ST. TAMMANY PARISH

RE: NOI to Prepare Draft EIS for the Pearl River Basin, Mississippi Federal Flood Risk Management Project, Rankin and Hinds Counties, MS

St Tammany Parish comments for:

Pearl River Basin, Mississippi Section 211 Feasibility Study - Integrated Draft Feasibility and Environmental Impact Statement

Figure 2. Pearl River Reach near Proposed Alt. C Impoundment with Flow Characteristics

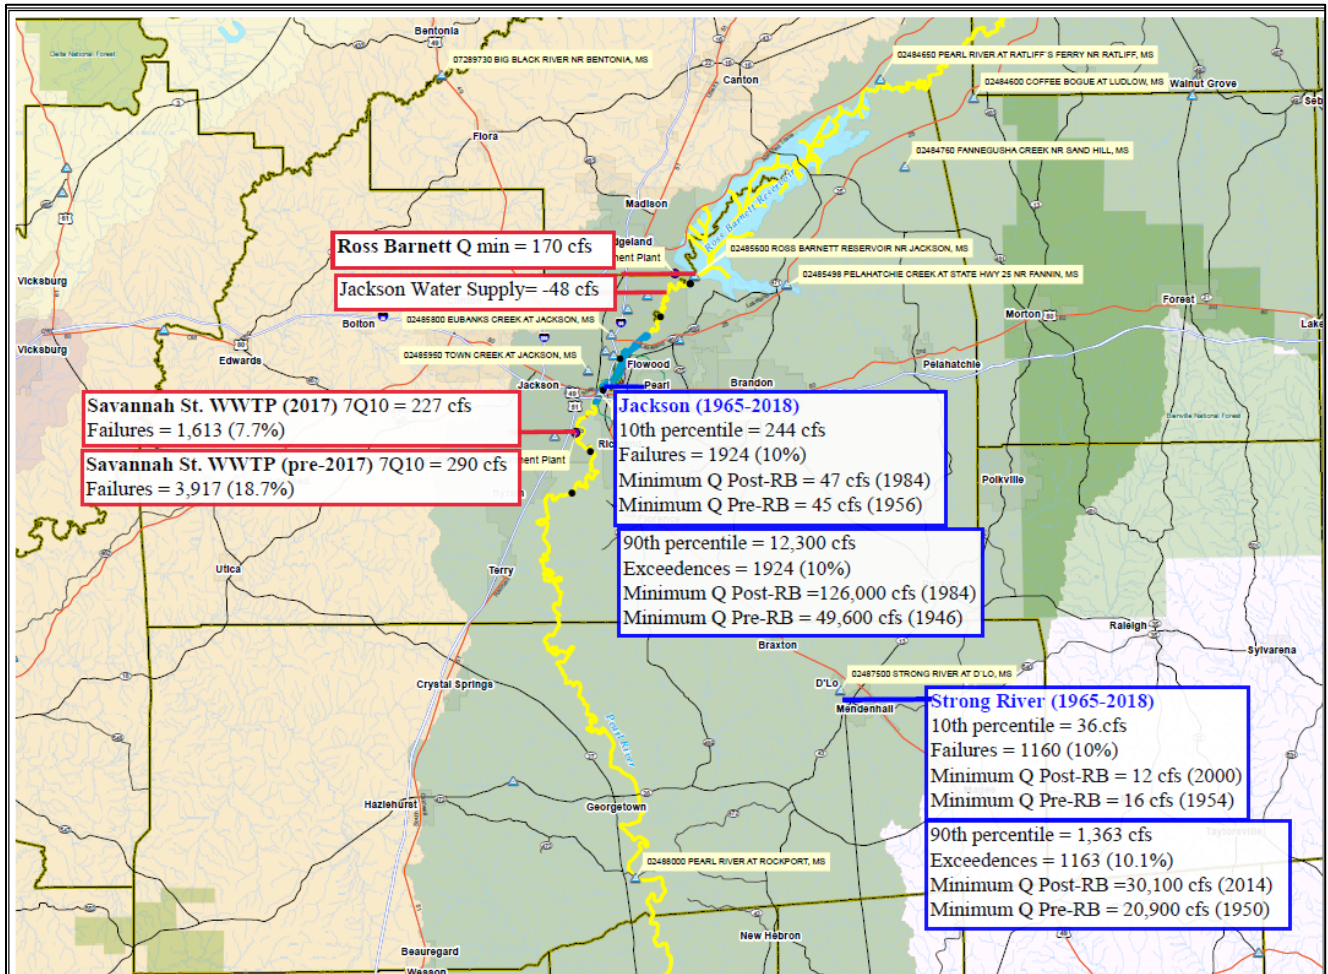
Construction of the Ross Barnett Reservoir (RB) began in 1960 and was completed in 1963. The 33,000 surface acre lake reached “full-pool” capacity in 1965¹. Following construction of the Ross Barnett Reservoir near Jackson, MS. Minimum Mean Daily Discharges have remained approximately the same, from 45 cfs (10/5/1956) to 47 cfs (6/14/1984) for pre-RB versus post-RB, respectively (Figure 2).

Comparing Average Monthly Discharges for the Pre- and Post-RB periods of record, it can be seen that during the low-flow months, May – November, flows from the RB Reservoir were fairly homogenous and somewhat higher than pre-RB. However, during the critically low- flow months of July and August, flows from the Ross Barnett are lower post- than pre-RB (Table 2). Average Monthly Discharge values are not detailed enough to quantify the low-flow incidences that may cause significant harm to the downstream NPDES permittees and the environment.

- It is strongly suggested that the Ross Barnett Reservoir minimum discharges be increased.

Figure 3. Mean Daily Discharge for USGS 02486000 (Pearl River at Jackson, MS) for the period of record

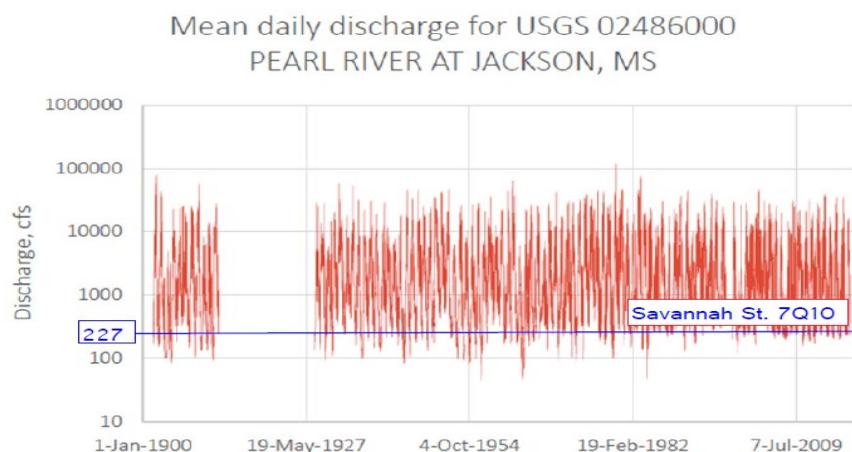
A 7Q10 of 227 cfs is the minimum stream baseflow measured on the USGS gage at Jackson required by MSDEQ for the most recent permit renewal (2017) for the 46 MGD City of Jackson Savannah St. WWTP discharge. Post-RB, there were 1,613 failures (7.7%) to meet this minimum flowrate (Figure 1). Mean Daily Discharge on the gage at Jackson show many measurements that are lower than the required 227 cfs for City of Jackson, Savannah St. Wastewater Treatment Plant (WWTP), as seen on the hydrograph in Figure 3.

The previous NPDES permit for the Savannah St. WWTP set the stream baseflow at 290 cfs for which there were 3,917 failures (18.7%). It seems counter intuitive that the permit should have been issued with a lower stream baseflow, with the River’s history of not attaining adequate flow. A TMDL for Nutrients² was implemented by EPA and MSDEQ in 2015 for the Pearl River from Ross Barnett to the Strong River. It seems plausible that inadequate stream baseflow at the Jackson gage during summer-critical conditions may be contributing to the lack of assimilative capacity at this location in the River incurring the TMDL.

Figure 4. Pearl River Reach near Monticello, MS with Flow Characteristics

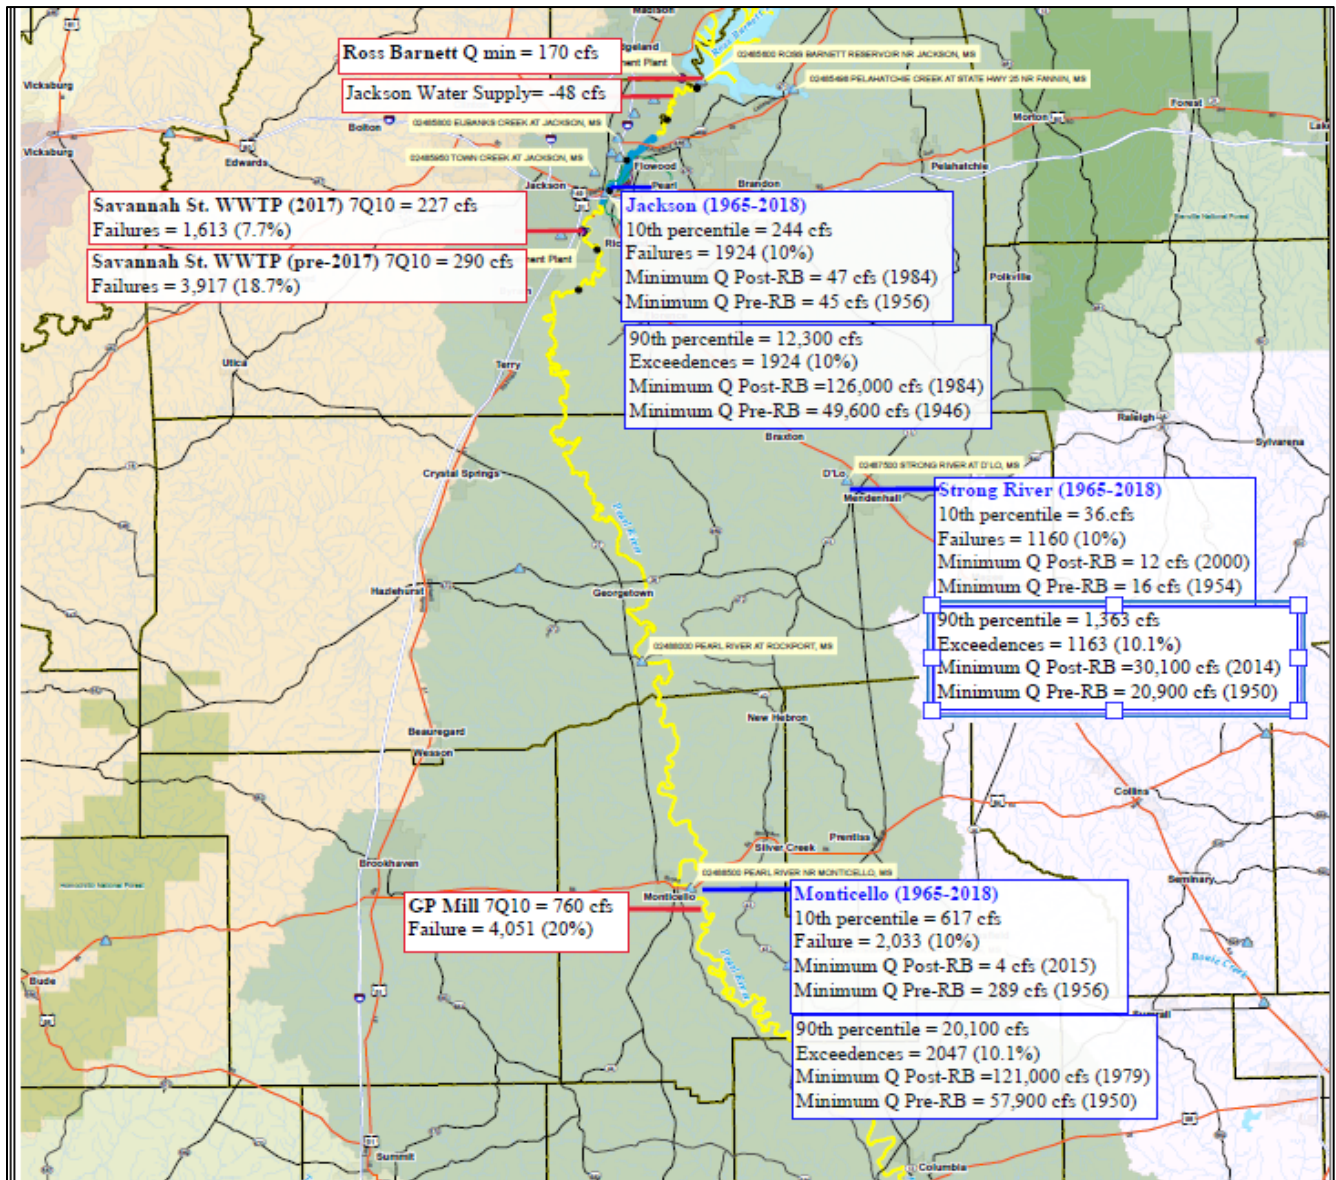
Monticello, MS is the location of a large NPDES discharger, Georgia Pacific (GP) Paper Mill (Figure 4). The 10th percentile flow post-RB is 512 cfs measured at the gage USGS 02488500 Pearl River at Monticello, MS, of which there were 854 measurements that failed to meet the 10th percentile (11%). The historic minimum flow at that location is 4.02 cfs. Residents along the River relay stories that the water was so low at that time that one could walk across to the other bank.

The 7Q10 for the 26.04 MGD (40.3 cfs) GP facility requires a stream baseflow of 760 cfs. There were 4,051 Daily Mean Discharge measurements (20%) that failed to meet that minimum. The Strong River, upstream of the Monticello gage, augments flow at this location (Figure 1); however, the post-RB 10th percentile for the Strong is 36 cfs measured at USGS 02487500 Strong River at D’Lo, MS. 1,160 Daily Mean Discharges failed to meet the 10th percentile (10%). The historic minimum was 12 cfs (8/31/2000).

- Clearly, stream baseflow, even with augmentation from the Strong River, is inadequate to meet the permit needs for this facility.

Figure 5. Pearl River Reach near Bogalusa, LA with Flow Characteristics

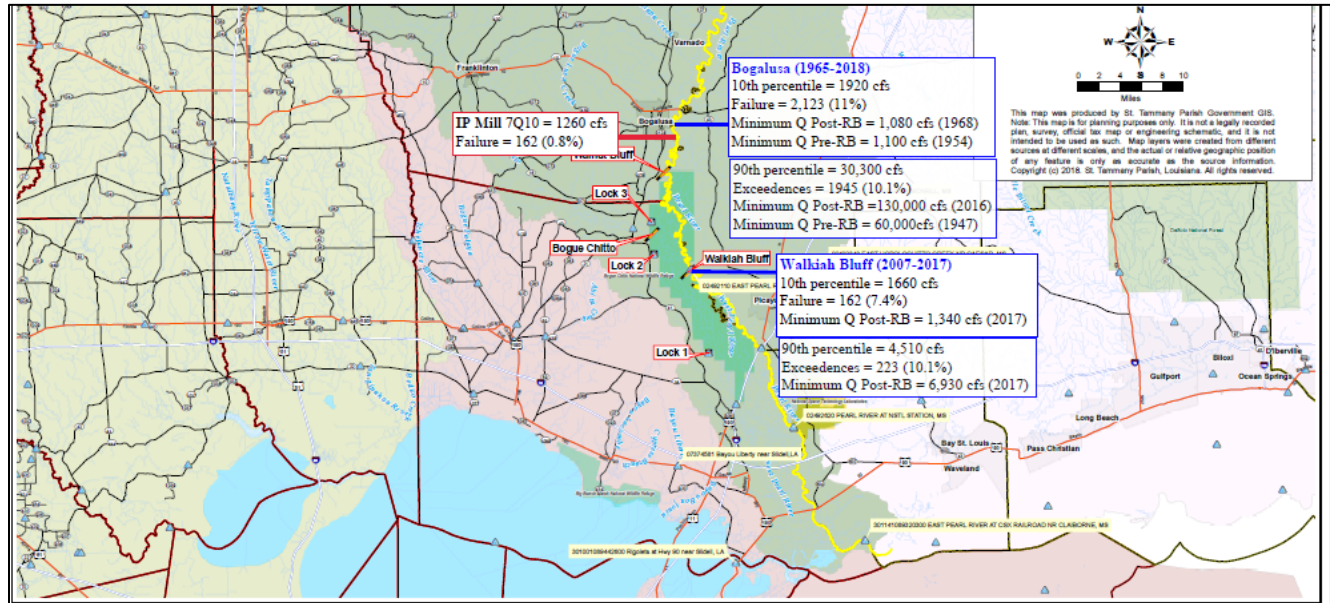
Bogalusa, LA is the location of a large NPDES discharger, International Paper (IP) Mill (Figure 5). The 10th percentile flow post-RB is 1,920 cfs, of which there were 2123 Daily Mean Discharges that failed to meet the 10th percentile (11%). The historic post-RB minimum flow at that location is 1,080 cfs. The 7Q10 for the 16 MGD (24.8 cfs) IP facility requires a stream baseflow of 1,260 cfs. There were 162 post-RB Daily Average Discharge measurements (0.8%) that failed to meet that minimum. While the minimum stream baseflow for this facility was well determined for the permit, there is little margin of safety in the stream baseflow, potentially incurring in-stream water quality violations during summer-critical conditions.

- There is a need for additional stream baseflow augmentation at this location in the Pearl River.

This site is of particular interest to oyster culture in coastal MS and LA (Figure 5). Adequate freshwater during summer critical conditions is necessary to mitigate the effects of saltwater intrusion and survivability of oysters in Lake Pontchartrain and the Mississippi Sound. Walkiah Bluff was constructed by the USACE to divert freshwater to the East Peal River during low-flow conditions. The 10th percentile Daily Mean Discharge measured at this gage is 1,660 cfs, of which 162 measurements <10th percentile (2007-2018). The historic minimum flow was 1,340 cfs (10/15/2007). A significant amount of debris is reportedly blocking the structure’s weir lessening the amount of fresh water being diverted.

- It is suggested that the USACE conduct maintenance on the Walkiah Bluff structure to restore its capacity.

Figure 6. Minimum Mean Daily Flows by Month minus proposed evaporative losses

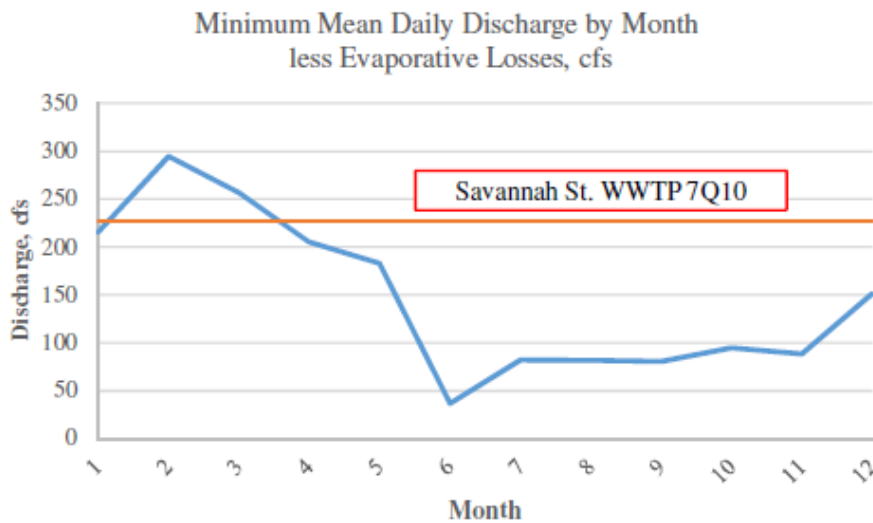
The EIS authors calculated evaporative losses from the proposed 1900 surface acre.

- Evaporative losses subtracted from either the Minimum Daily Mean Discharges by Month (Figure 6) or the 10th percentile of Mean Daily Discharges (Table 5) indicate the already-impacted Pearl River will be further compromised.

Figure 9. Predicted DO vs Observed DO at Sample Location downstream of the Ross Barnett gates

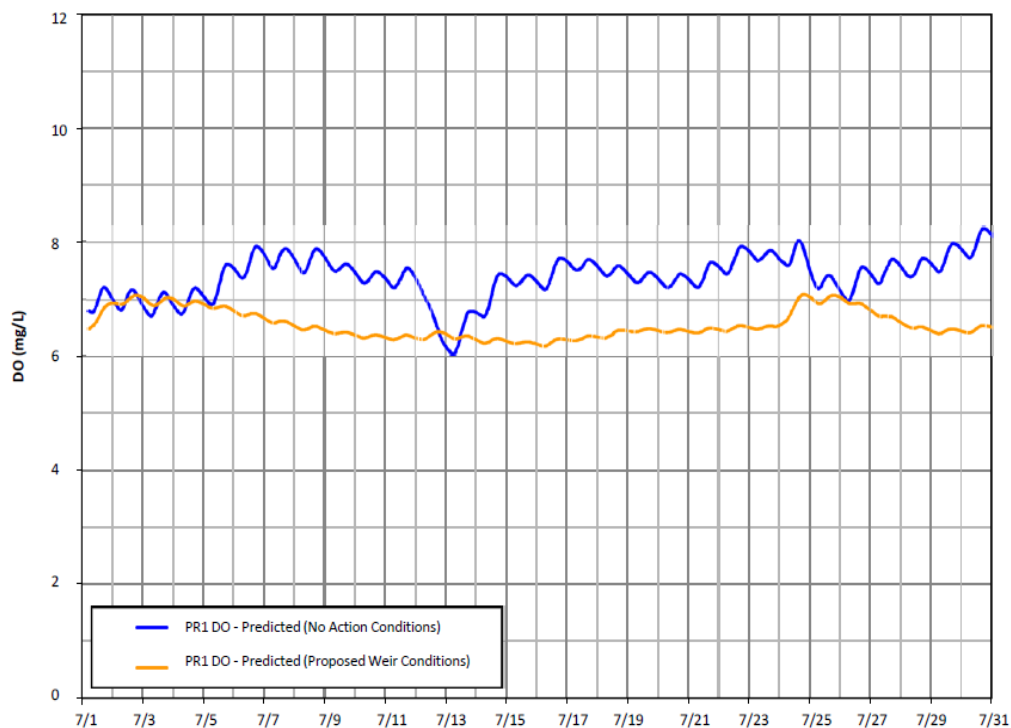
Using data from the July 2014 sampling event, the EIS team developed a model to predict the impact of the proposed impoundment. Figure 9 (EIS Appendix D, Water Quality, pg.119) presents model output of dissolved oxygen (DO) for two scenarios: 1) “No Action” (current conditions) and 2) Alternative C scenario. In the “No action” scenario, DO is significantly higher than the Alt. C scenario; however, EIS reviewers are assured that the DO in the Alt. C scenario will remain above the CWA criteria of 5.0 mg/L. Reviewers are asked to believe that the flow rates, pollutant concentrations, temperatures and decay coefficients used in the model are also correct. Assuming the 10th percentile flow rates were to be used, it is doubtful that the DO would maintain CWA DO minimums.

- St. Tammany Parish requests that a modeling scenario be conducted using “worse-case conditions” of 10th percentile flow rates and 32^oC temperatures, with a minimum 20% increased loadings to represent a margin of safety for growth.

Figure 10. Locations of Coastal Restoration Projects and CRMS sites in the Pearl River vicinity

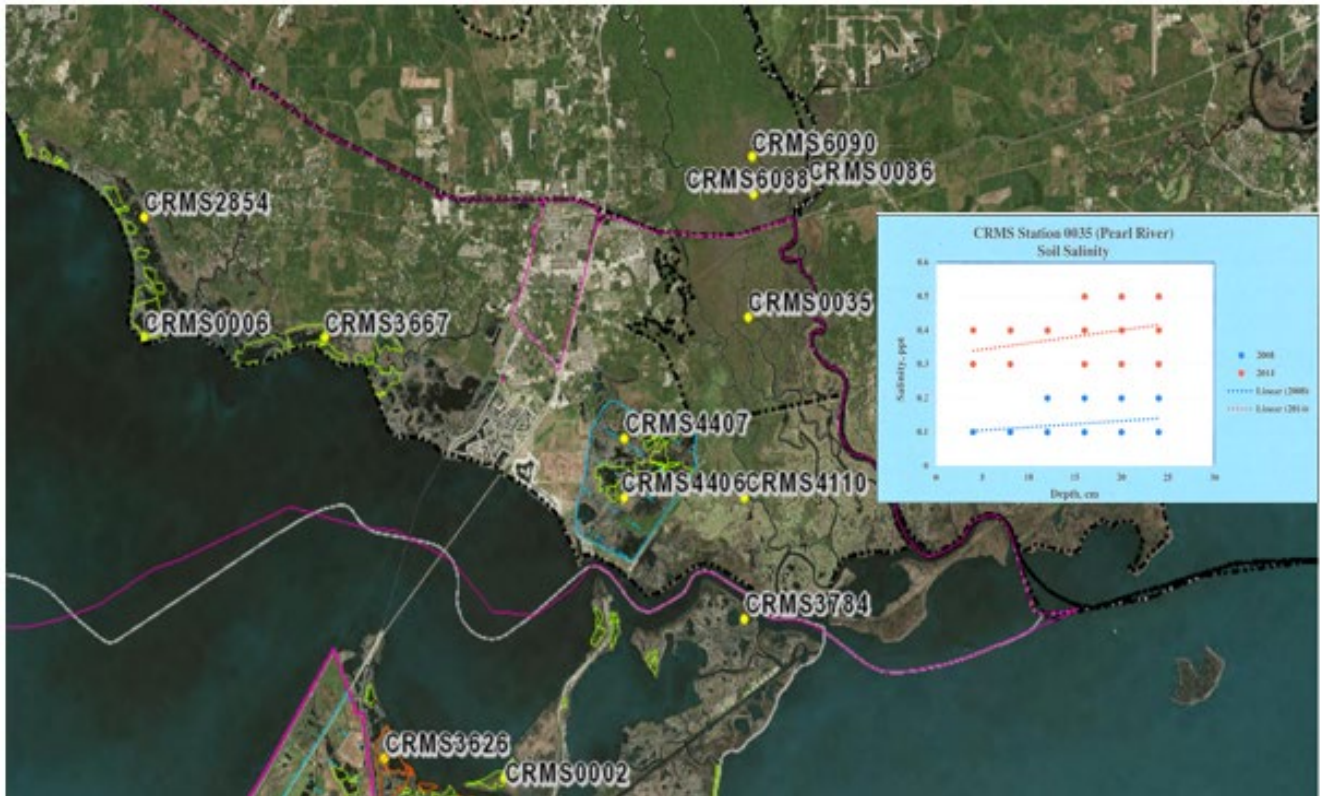
Since 2006, the Louisiana Coastal Protection and Restoration Authority (CPRA) and the US Geological Survey (USGS) have developed and maintained a Coastwide Reference Monitoring System (CRMS) for wetland restoration efforts. There are three CRMS sites in the vicinity of coastal Pearl River and a number of coastal restoration projects that are in the construction or engineering/development phase (Figure 10). These projects are vital to the restoration and resiliency of the Louisiana coastline and provide surge protection to inland communities.

The CRMS site houses monitoring datasets of hydrogeomorphological parameters that characterize coastal habitats in Louisiana. Some of the parameters that are monitored include water level, soil porewater salinity, percent organic content and surface elevation/accretion. The CRMS site link is: <http://www.lacoast.gov/crms2/Home.aspx>. All CRMS indicate increased saline concentration in porewater, perhaps attributable to less fresh water flowing down the Pearl River in low flow months.

- St. Tammany Parish recommends that monitoring at the CRMS sites continue, particularly to monitor for salt water intrusion.
